PRODUCT CHANGE NOTIFICATION (PCN)

AMJS1010-0200-BKB-26 MODULAR CABLE

CHANGE NOTIFICATION:	PCN 20220425_AMJS1010-0200-BKB-26
DESCRIPTION OF CHANGES:	CHANGE OF DATA SHEET CHANGE OF DATA SHEET New Draw.-No. ASS_7943_CArev02
REASON FOR CHANGE:	CHANGE OF PRODUCT LOCATION CHANGE OF PRODUCT LOCATION
KEY CHARACTERISTICS OF CHANGE:	Details see page 3
PRODUCTS AFFECTED:	AMJS1010-0200-BKB-26
DATE OF CHANGE AND IMPLEMENTATION:	CHANGE: WEEK 18 / YEAR 2022 IMPLEMENTATION: 25/4/2022
RESPONSE:	NO RESPONSE TO THIS NOTIFICATION IS REQUIRED

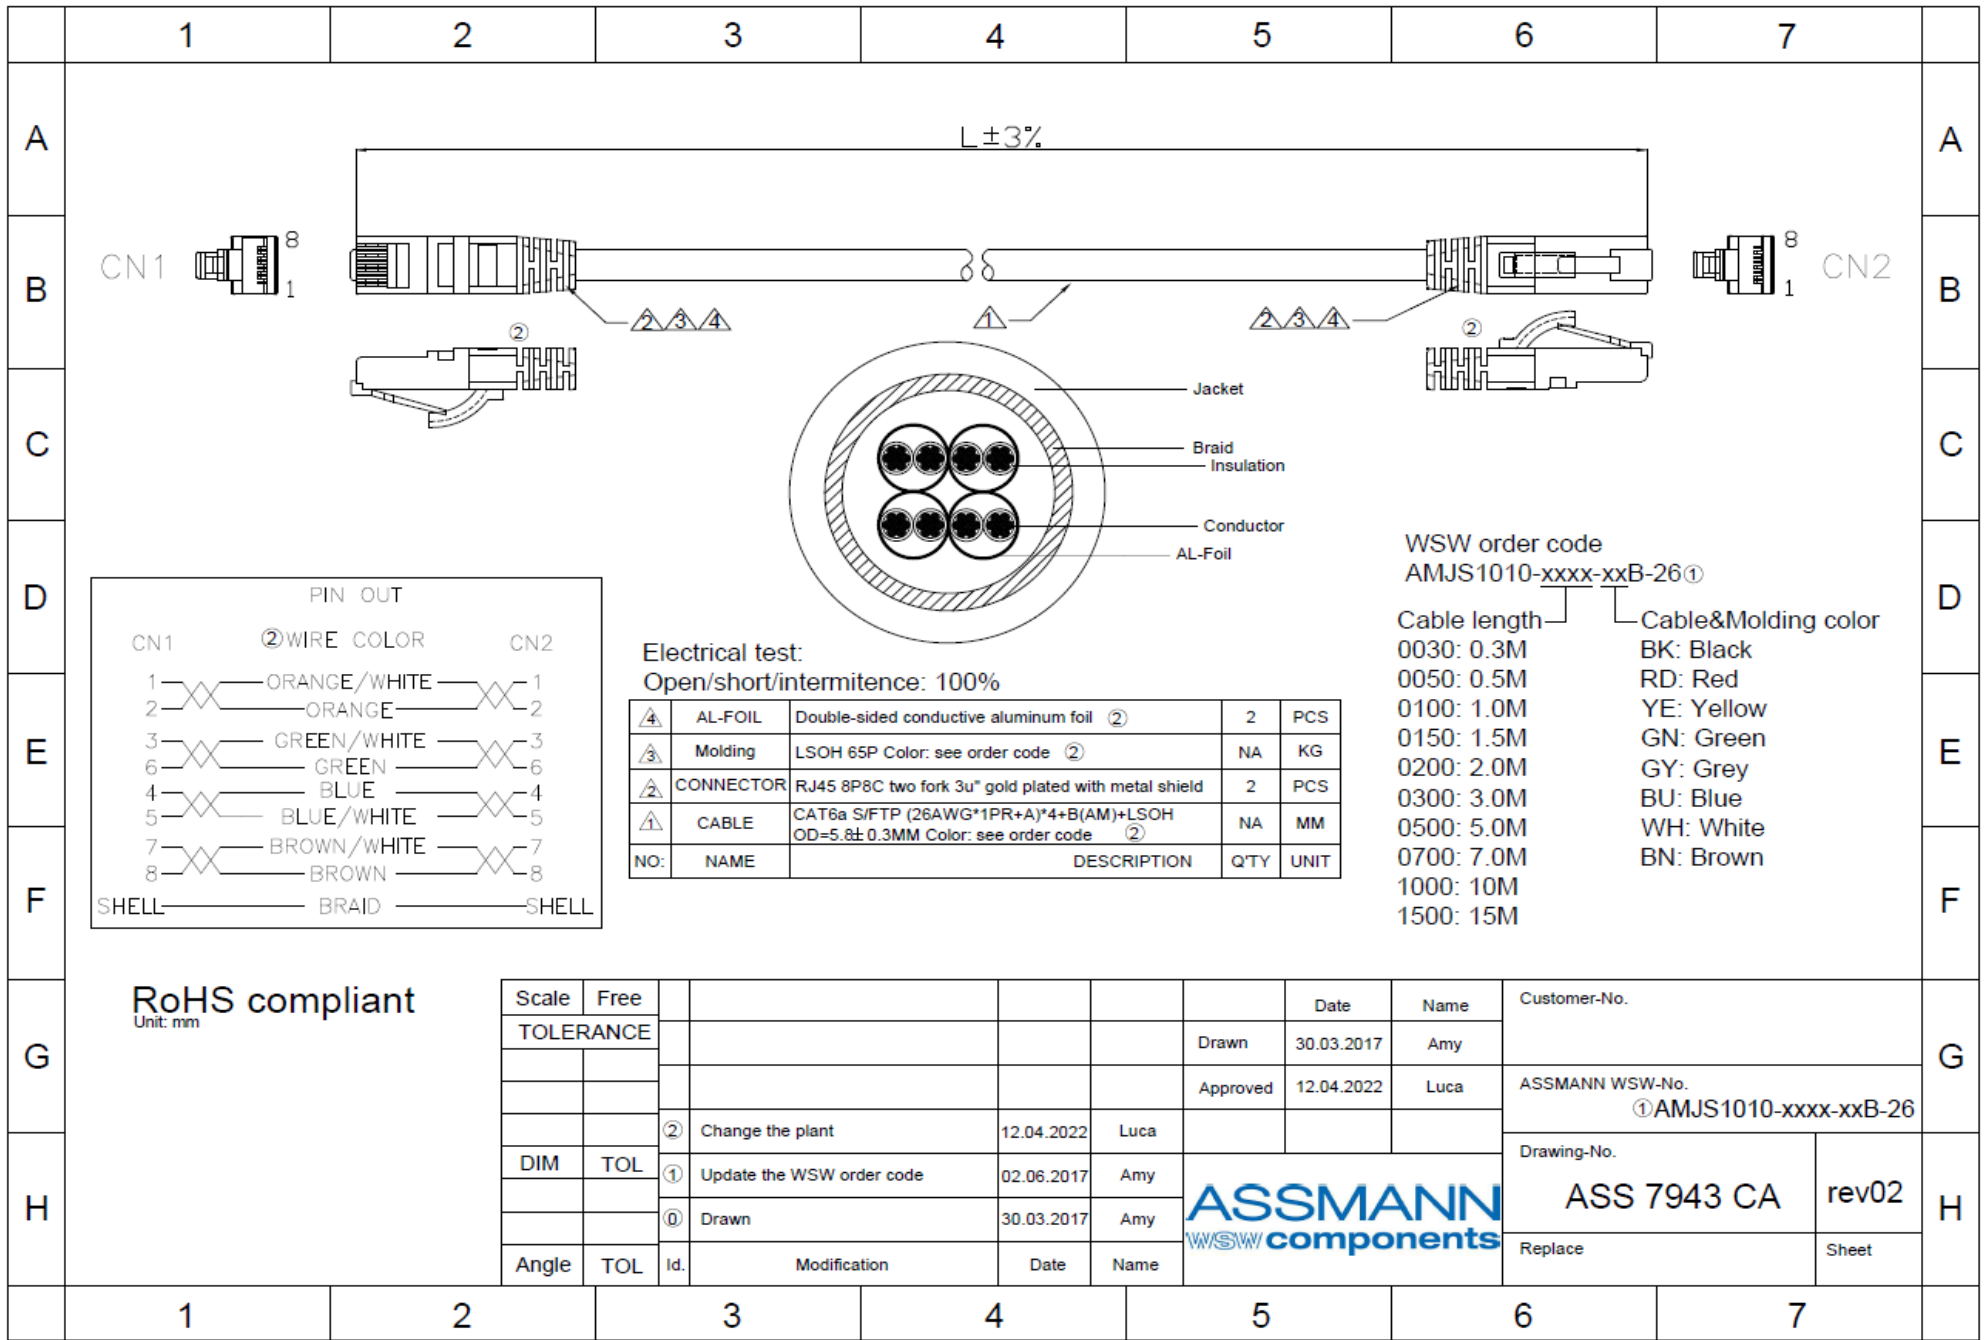
AMJS1010-0200-BKB-26	OLD VERSION	AMJS1010-0200-BKB-26	NEW VERSION																																													
<p>Appearance</p>		<p>Appearance</p>																																														
<p>BOM</p> <table border="1"> <thead> <tr> <th>NO:</th> <th>NAME</th> <th>DESCRIPTION</th> <th>Q'TY</th> <th>UNIT</th> </tr> </thead> <tbody> <tr> <td>③</td> <td>Molding</td> <td>LSOH PVC 45P Color: see order code</td> <td>NA</td> <td>KG</td> </tr> <tr> <td>②</td> <td>CONNECTOR</td> <td>RJ45 8P8C two fork 3u" gold plated with metal shield</td> <td>2</td> <td>PCS</td> </tr> <tr> <td>①</td> <td>CABLE</td> <td>CAT6a S/FTP (26AWG*1PR+A)*4+B+LSOH OD=5.8±0.3MM Color: see order code</td> <td>NA</td> <td>MM</td> </tr> </tbody> </table>		NO:	NAME	DESCRIPTION	Q'TY	UNIT	③	Molding	LSOH PVC 45P Color: see order code	NA	KG	②	CONNECTOR	RJ45 8P8C two fork 3u" gold plated with metal shield	2	PCS	①	CABLE	CAT6a S/FTP (26AWG*1PR+A)*4+B+LSOH OD=5.8±0.3MM Color: see order code	NA	MM	<p>BOM</p> <table border="1"> <thead> <tr> <th>NO:</th> <th>NAME</th> <th>DESCRIPTION</th> <th>Q'TY</th> <th>UNIT</th> </tr> </thead> <tbody> <tr> <td>△4</td> <td>AL-FOIL</td> <td>Double-sided conductive aluminum foil ②</td> <td>2</td> <td>PCS</td> </tr> <tr> <td>△3</td> <td>Molding</td> <td>LSOH 65P Color: see order code ②</td> <td>NA</td> <td>KG</td> </tr> <tr> <td>△2</td> <td>CONNECTOR</td> <td>RJ45 8P8C two fork 3u" gold plated with metal shield</td> <td>2</td> <td>PCS</td> </tr> <tr> <td>△1</td> <td>CABLE</td> <td>CAT6a S/FTP (26AWG*1PR+A)*4+B(AM)+LSOH OD=5.8±0.3MM Color: see order code ②</td> <td>NA</td> <td>MM</td> </tr> </tbody> </table>		NO:	NAME	DESCRIPTION	Q'TY	UNIT	△4	AL-FOIL	Double-sided conductive aluminum foil ②	2	PCS	△3	Molding	LSOH 65P Color: see order code ②	NA	KG	△2	CONNECTOR	RJ45 8P8C two fork 3u" gold plated with metal shield	2	PCS	△1	CABLE	CAT6a S/FTP (26AWG*1PR+A)*4+B(AM)+LSOH OD=5.8±0.3MM Color: see order code ②	NA	MM

NO:	NAME	DESCRIPTION	Q'TY	UNIT																																												
③	Molding	LSOH PVC 45P Color: see order code	NA	KG																																												
②	CONNECTOR	RJ45 8P8C two fork 3u" gold plated with metal shield	2	PCS																																												
①	CABLE	CAT6a S/FTP (26AWG*1PR+A)*4+B+LSOH OD=5.8±0.3MM Color: see order code	NA	MM																																												
NO:	NAME	DESCRIPTION	Q'TY	UNIT																																												
△4	AL-FOIL	Double-sided conductive aluminum foil ②	2	PCS																																												
△3	Molding	LSOH 65P Color: see order code ②	NA	KG																																												
△2	CONNECTOR	RJ45 8P8C two fork 3u" gold plated with metal shield	2	PCS																																												
△1	CABLE	CAT6a S/FTP (26AWG*1PR+A)*4+B(AM)+LSOH OD=5.8±0.3MM Color: see order code ②	NA	MM
